**NSLPP MEETING HELD ON 02/04/2025**

**ADDRESS/WARD:** 35 East Crescent Street Lavender Bay

**APPLICATION No:** 175/24

**PROPOSAL:** Demolition of a dwelling house, construction of a new dwelling house and associated works.

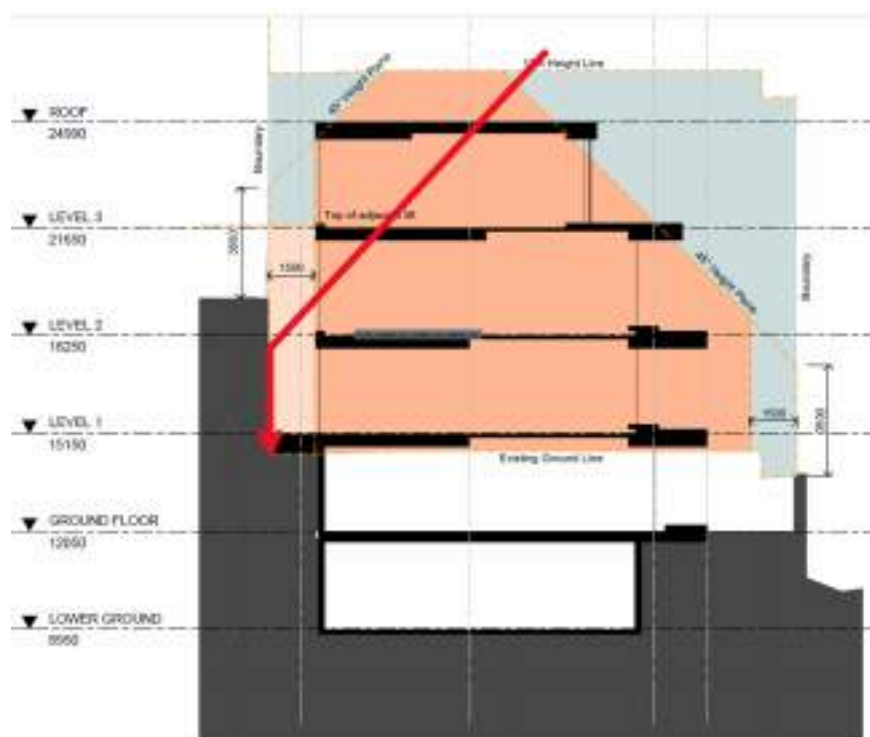
- (a) *The building envelopes that appear to have informed the proposed design have been miscalculated by using incorrect ground levels.*
- (b) *The proposed development is inconsistent with the objectives of and does not comply with the controls in Section 1.4.6 in Part B of NSDCP 2013 relating to side setbacks, the building height plane and the rear setback.*
